## **EXHIBIT 1**

On August 21, 2014, Piper Peterson (USEPA) sent the following comments to Allison Crowley (City of Seattle). This exhibit addresses the comments as indicated in orange.

**Figure 1.**  
 Stormwater Outfall Profile Shown with Soil Stratigraphy and Final Port Excavation Grades  
 Lower Duwamish Waterway Superfund Site  
 T-117 Early Action Area

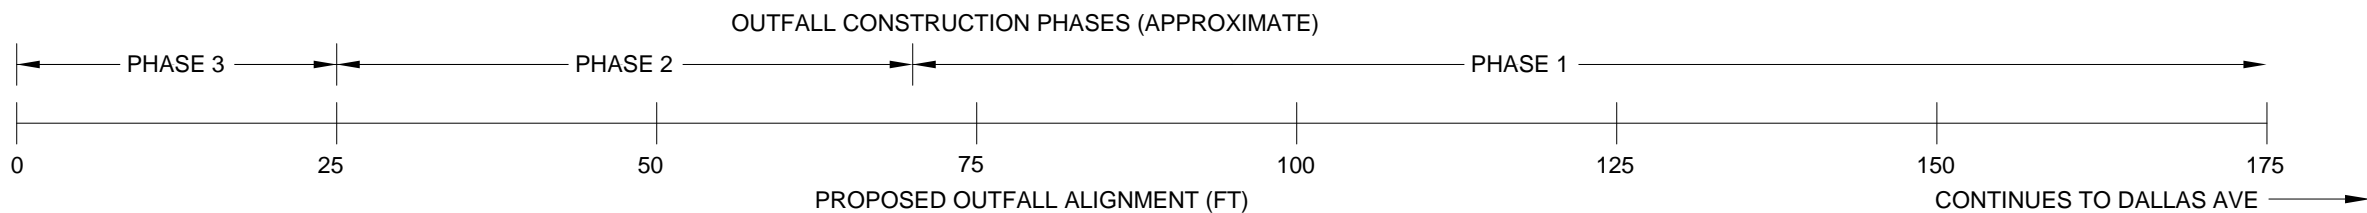
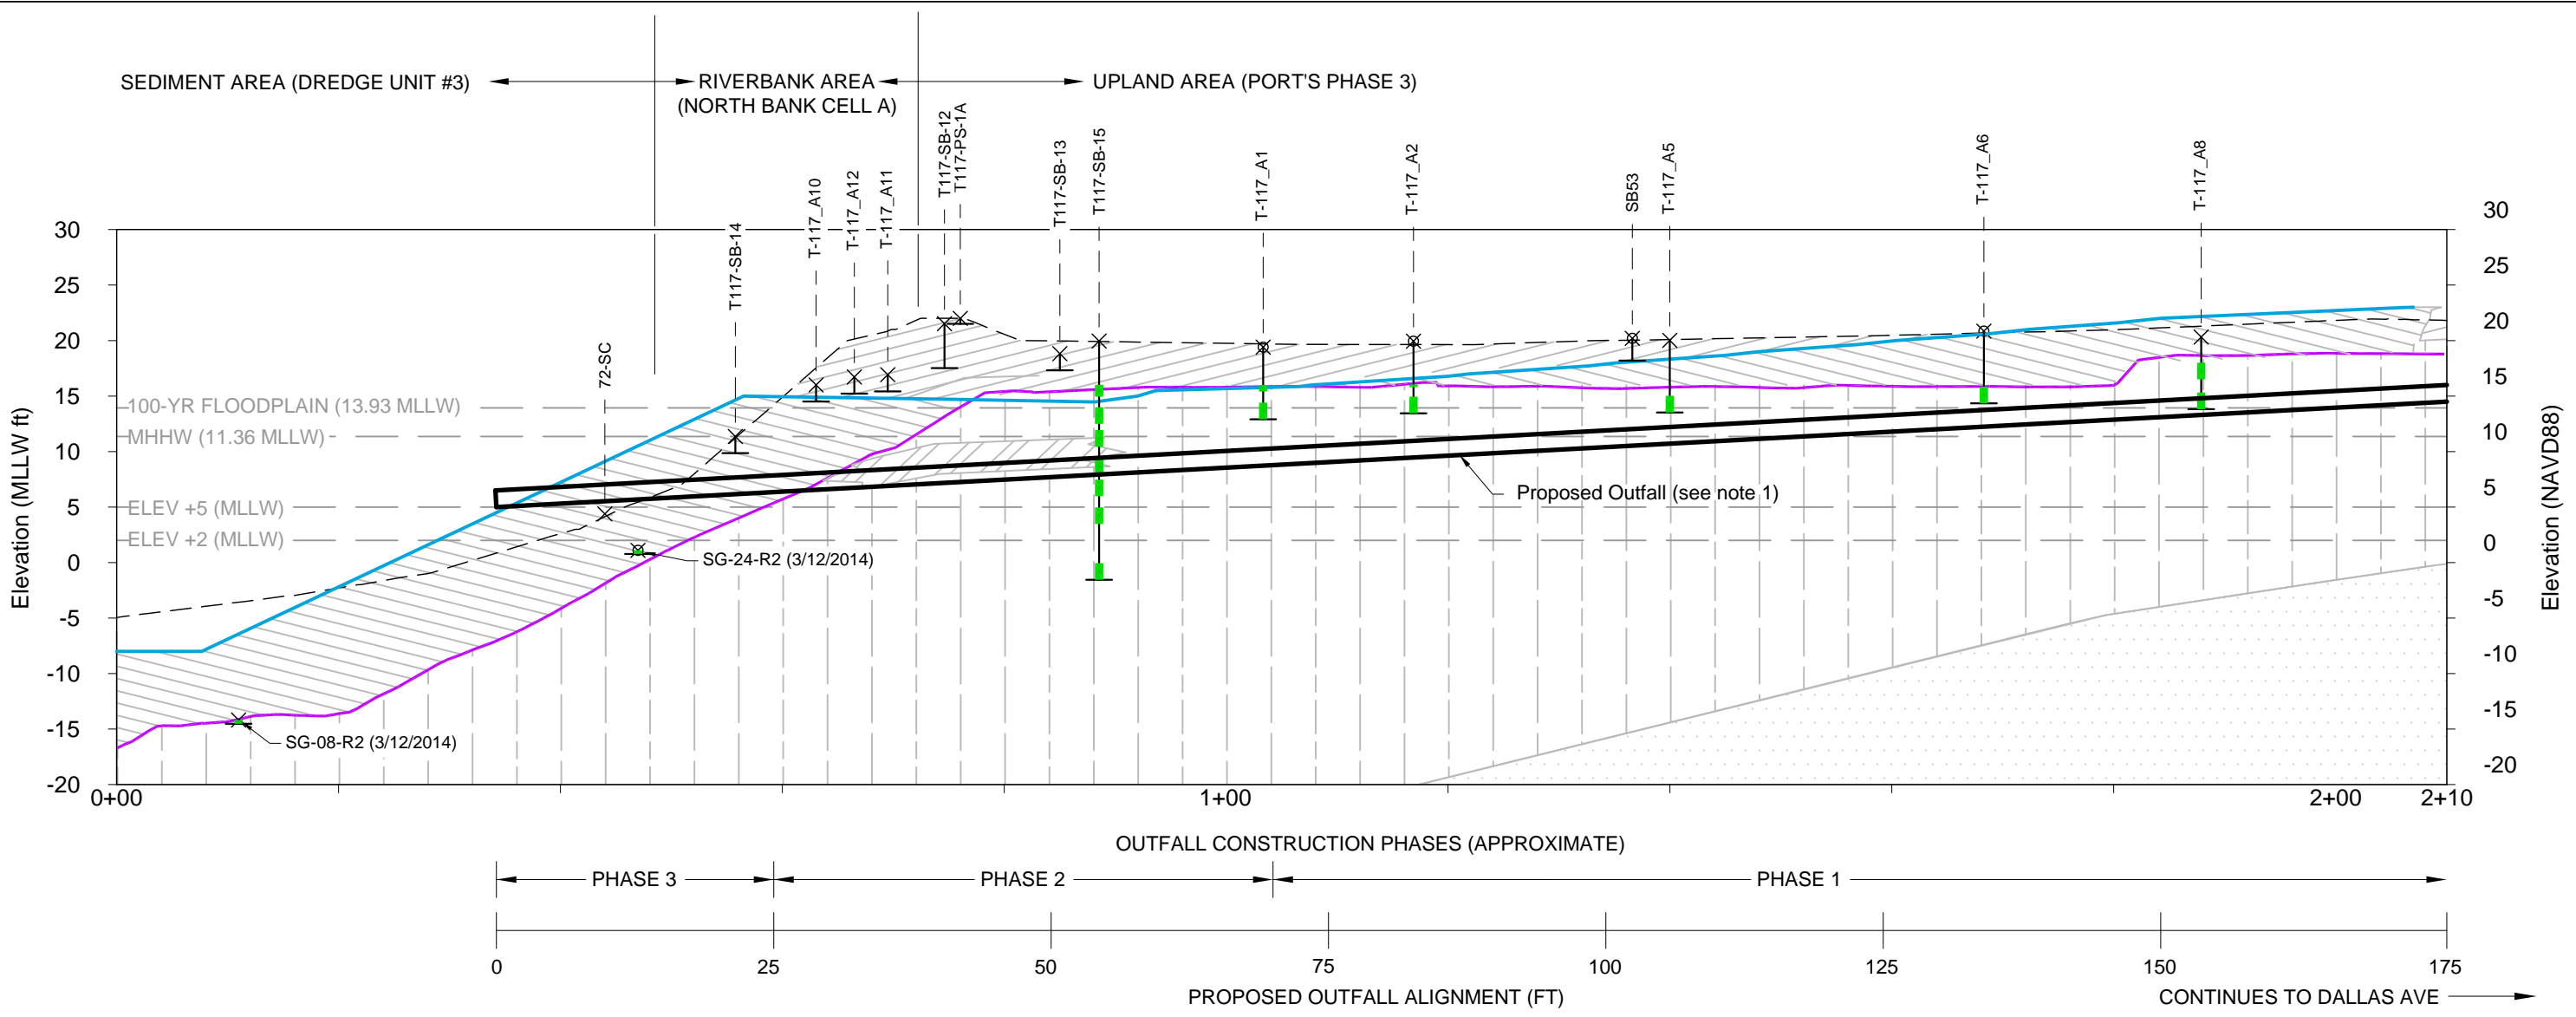
1. EPA Comment: Figure 2-2. Identify the excavation depth of the Port's final removal provided in Figure 2-6 in the area of the City's proposed outfall location onto Figure 2-2 so the reviewer can identify the depth of soil excavated for the outfall pipe that is deeper than soils excavated for the Port's removal project. Identify the volume of existing, aka "native" material (not including Port backfill) to be removed for placement of the outfall pipe.

3. EPA Comment: Figure 3-8a. Identify the existing soil sample locations, depth of sample and sample results in the location of the City's proposed outfall pipe. State whether the Port's removal project removed soil to these depths. According to this figure, there may be up to 8 samples in this area. PCBs with greater or equal to 50 ppm PCBs are identified on Figure 3-9a at 2 sample stations-SB53 (60 ppm PCB) and T117-PS-2A (66 ppm PCB). It is unclear if sample stations T-117 A6, T-117 A5, T-117 A7, and T-117 A2 are in the underlying soils beneath the Port's excavation area in the location of the proposed outfall pipe. Reviewing Map 2-13a, EE/CA map folio, there are approximately 13 total on-site sampling stations in this location, but some of these are not presented on Figure 3-9a.

4. EPA Comment: As per map 2-13b (EE/CA map folio dated July 3, 2010), there are virtually no soil samples from the location of the City's proposed outfall location from 7-9 bgs, 9-12 bgs or 12-15 bgs. The rationale is likely because the concentrations of PCBs were decreasing in the upper profiled layers 0-2 feet, 2-5 feet and 5-7 feet, however with no sampling done at these intervals. These intervals are likely more closely aligned with the depth of the outfall pipe installation.

*City Response: Excavation depths relative to the outfall are most clearly shown in RADR Figure 2-4. For clarity, the figure has been simplified to show only the final excavation depth (see Figure 1, attached), which is indicated in purple. The outfall trench will extend 4 inches below the outfall pipe. An estimated 130 cy of material from beneath the Port's excavation will be removed for placement of the outfall pipe. An additional 120 cy of material that was placed by the Port will be removed.*

*City Response: Figure 1 identifies outfall-vicinity samples, the depths at which samples were taken, and results relative to RvALs deeper than the Port's excavation. We have attached a data table for these samples and their results (for those analytes with RvALs).*

City Response: Figure 1 confirms that there are limited samples along the City's proposed outfall location from 7-9 ft bgs, 9-12 ft bgs, or 12-15 ft bgs.

**Figure 2.**  
 Chemistry Sampling Locations in the Proposed Outfall Vicinity  
 Lower Duwamish Waterway Superfund Site  
 T-117 Early Action Area

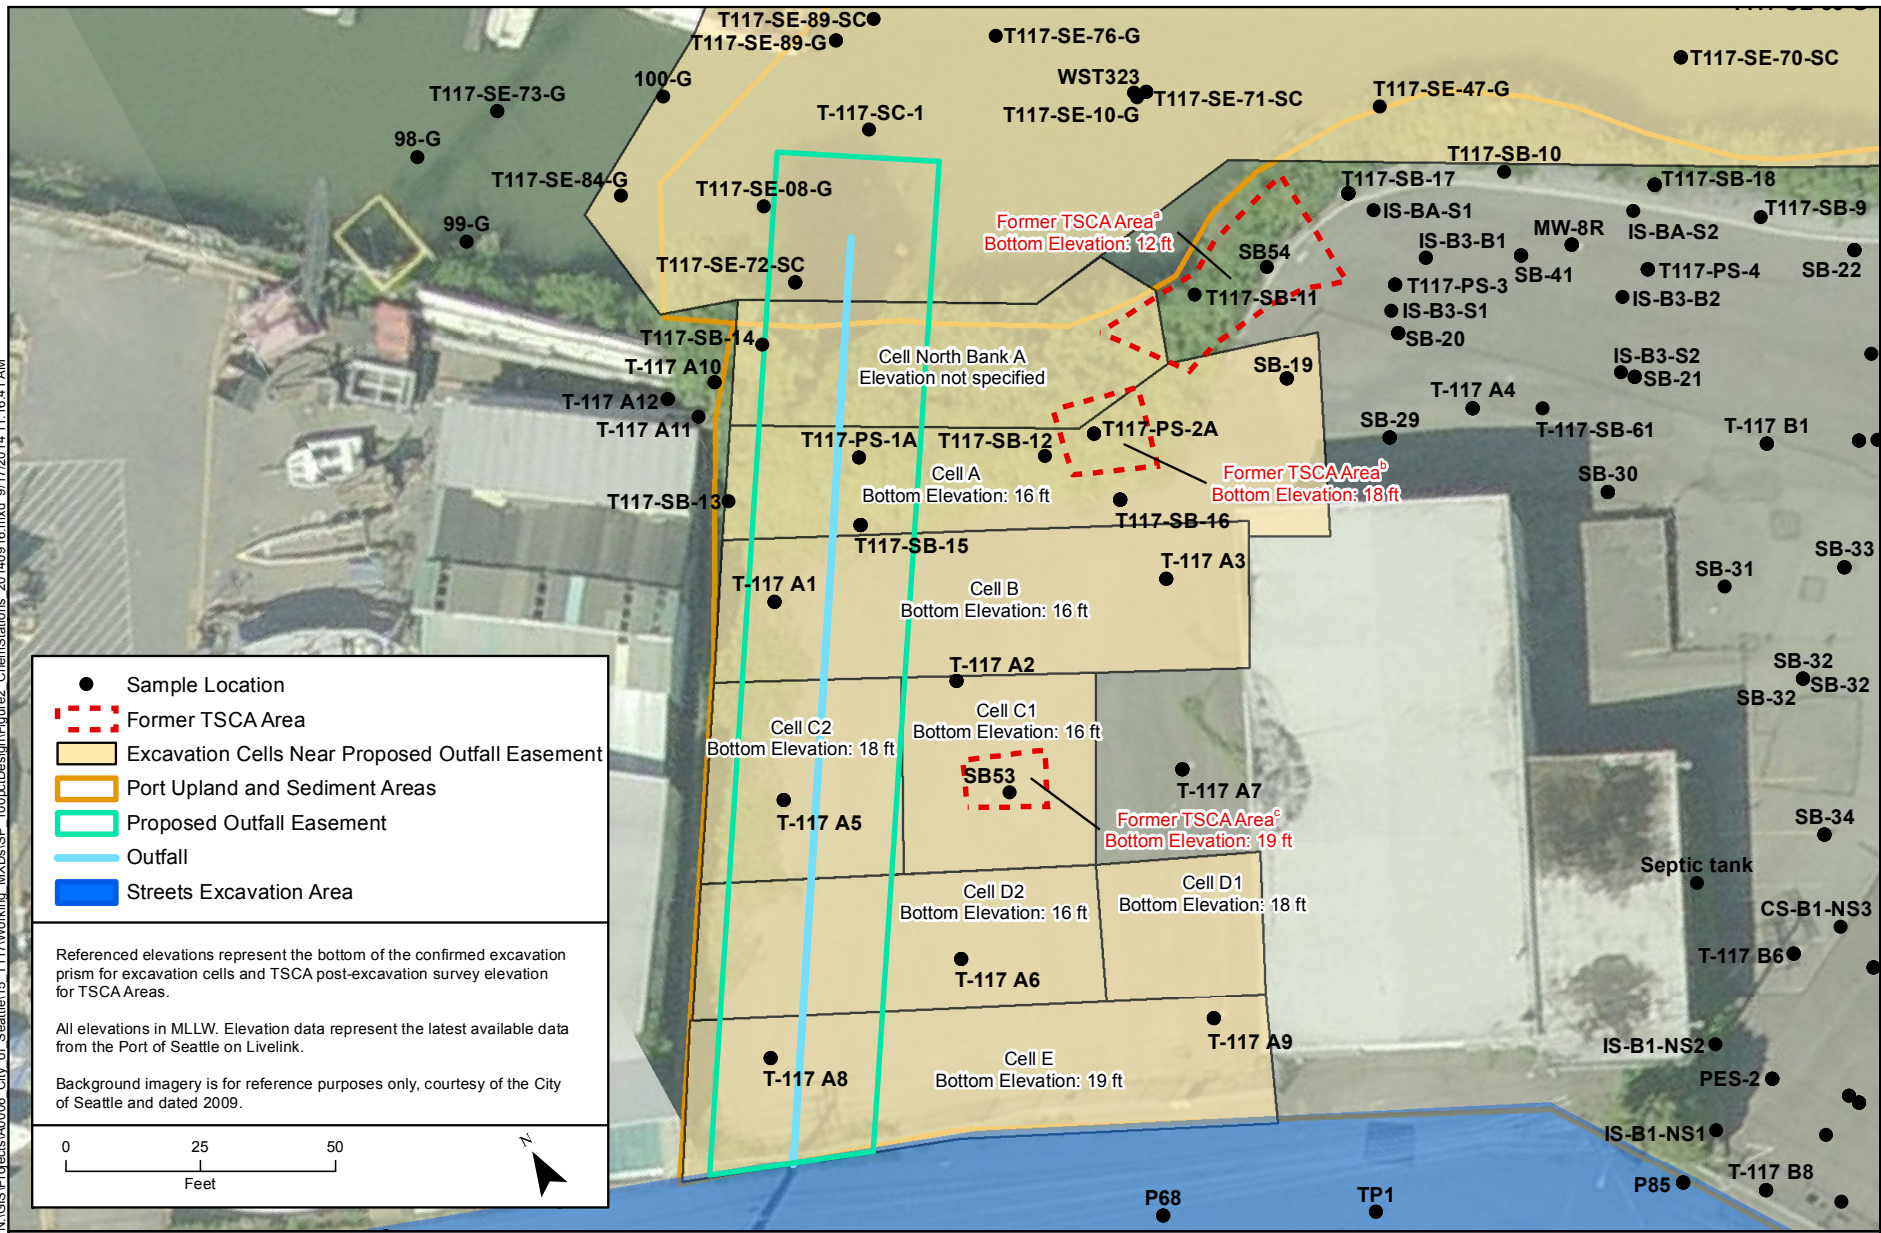
2. EPA Comment: Include the outfall pipeline on figures used by the City to demonstrate its location vis-à-vis on-site sample stations.

*City Response: Figure 2 (attached) combines the outfall and excavation information previously provided in RADR Figure 2-6 and FDR Figure 3-8a.*

The locations of SB53, T117-PS-2A, T-117 A6, T-117 A6, T-117 A7, T-117 A2 and the outfall are shown on Figure 2. T-117 A6, T-117 A7, and T-117 A2 are outside of the outfall easement.
